NEW FOR 2024

New Bulkhead Design...

2024 MY

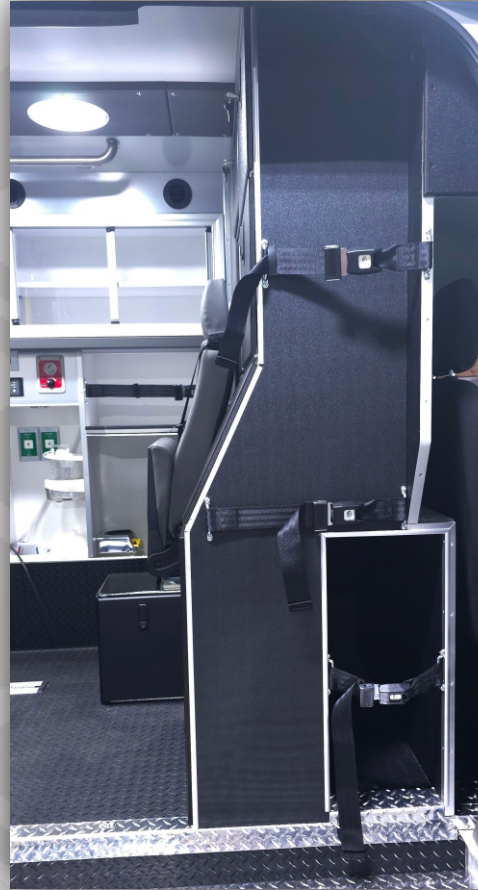
The Transit Bulkhead was redesigned to accommodate the storage for a Stair Chair without using up the valuable bulkhead space that's currently available.

The storage is now tucked up behind the cab seats while not compromising the maneuverability of the driver, and/or passenger. Leg room and tilt space was not changed on these seats.

The Stair Chair can be easily removed from the side-door by sliding the backboard over and pulling out the chair. Otherwise, it stays tucked in and out of the way when not in use.

This 10"W x 24"H x 38"D accommodates most popular chair sizes including track units.

Shown here with the Bulkhead Doors option, There is still ample storage room. The center cabinet below the window extends to the area behind the attendant seat to allow for even more storage space.

The lower cabinet can be used as a writing surface while in transit.
